Planning Commission Regular Meeting

Tuesday, May 19, 2026, 6:30 PM
106 Center Street

To: Planning Commission

Excelsior Good Neighbor Guidelines PLAN Review

ZEHNDER HOMES, INC.
138 2nd Street, Excelsior, MN 55331

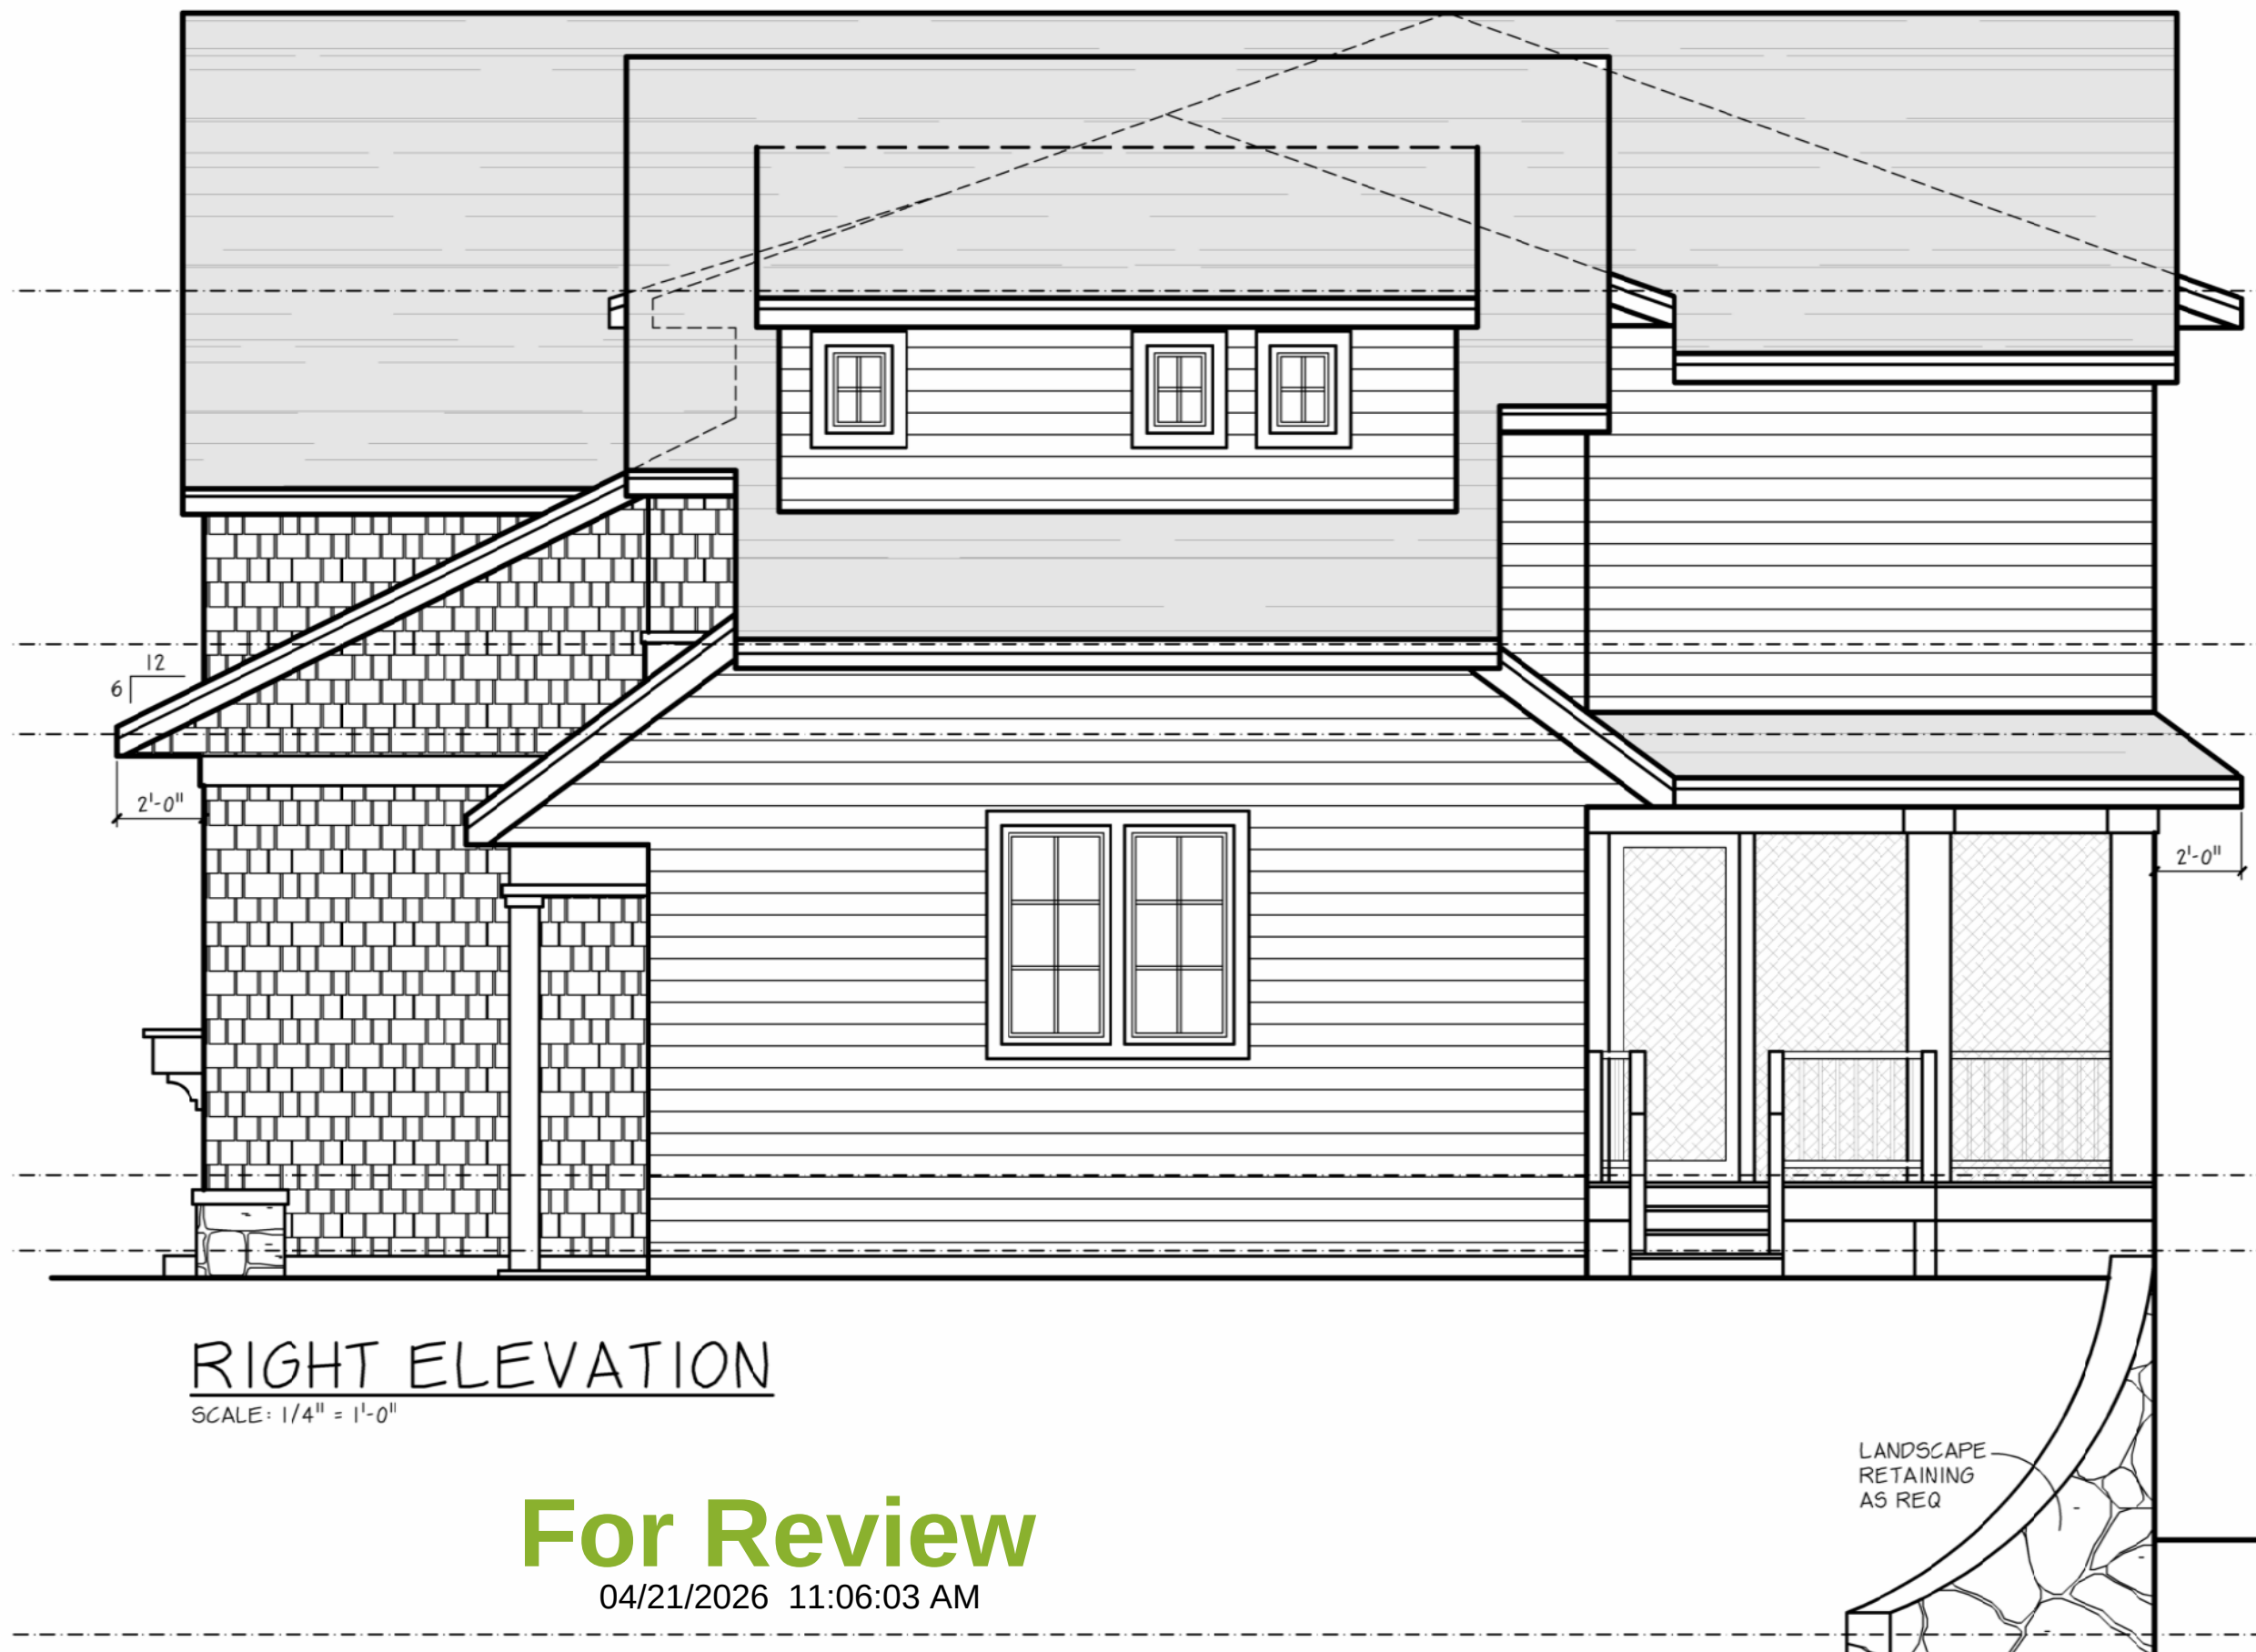
The proposed new 6-6 deep x 12-7 wide entrance porch frames the entrance facing 2nd Street. It is partial single story, with a second story gabled dormer above half of it. Garage shows columns supporting a roof overhang in plans and drawing elevations but not in renderings; applicant should clarify which version is proposed.
